RESPONSE TO SUDS

Planning Application: Land North of Taylors Farm

Application Reference: UTT/25/2786/OP

Document Status: Formal Written Objection

Picture 2

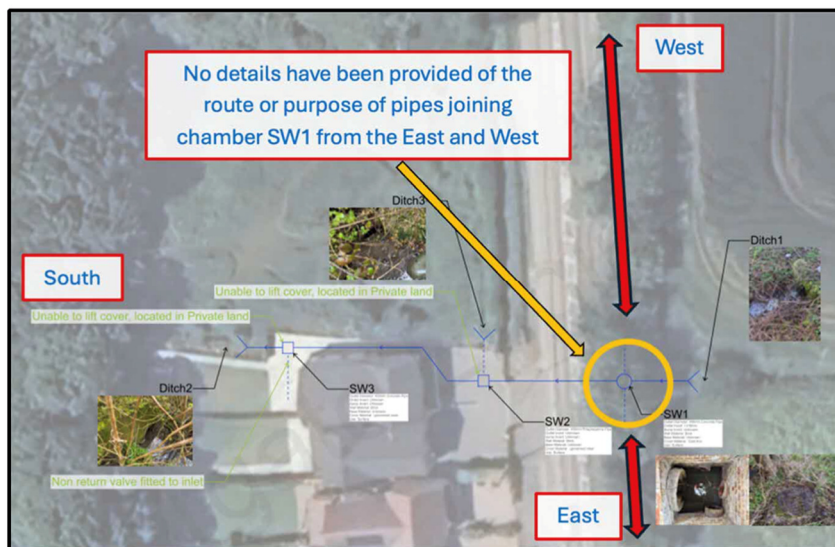
Extract from TSAG Dec 2025 comments detailing the SSFRA CCTV report which ignores specific details regarding the culverts East and West of the inspection Chamber indicated in the picture below. No further evidence has been supplied by the Developer.

Further investigation of the roadside ditch and Highway Drains connections are required.

Picture 3 Original diagram from South Uttlesford Site Development Templates

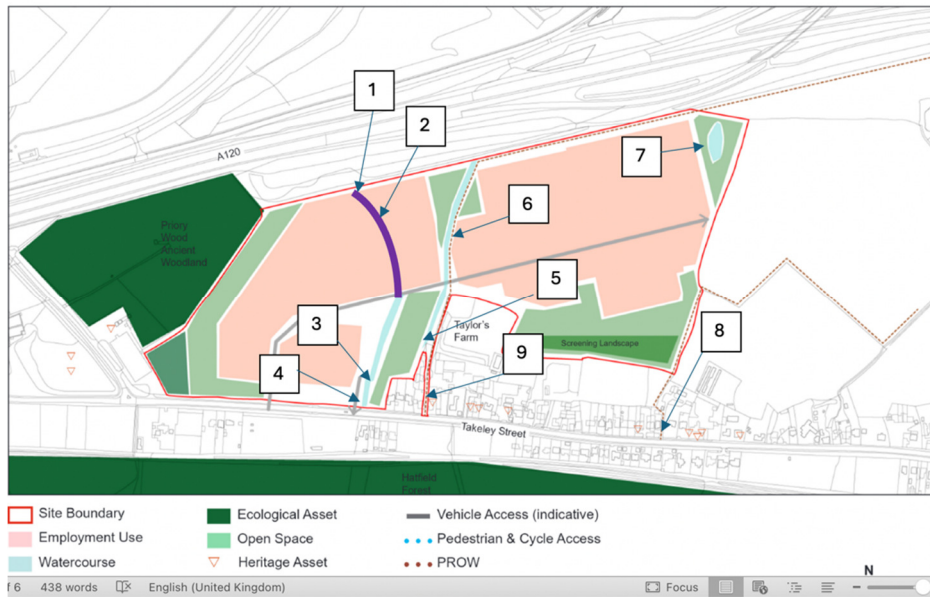
1. Inaccurate length of western watercourse. Actual length highlighted in purple.
2. Location of culvert outfall on western watercourse, arriving from north east angle. Length unknown, source unknown. Culvert diameter approximately 6 inches. Depth of brook approx. 6 foot. Evidence of old tress growing within brook to prove this is not a recently dug ditch.

3. Western watercourse culvert, approx. 5m in length presumably to allow tractors to cross. Modern, brick wall and concrete culvert.
4. Culvert from Western watercourse passing under B1256. Culvert diameter approximately 18 inches. Modern construction, brick wall surround.

5. Culvert from Eastern watercourse passing under B1256. Culvert diameter approximately 18 inches. Modern construction, brick wall surround. 2 additional culverts of modern plastic construction, unknown sources.

6. Eastern watercourse culvert, approx. 5m in length presumably to allow tractors to cross. Older style, made with timber.
7. Watercourse does not exist in the north-eastern boundary (although as this drawing is a future plan it may be part of their plans to have a pond here as the land does bank down in this section).

8. Depth of both watercourses approximately 6ft throughout.
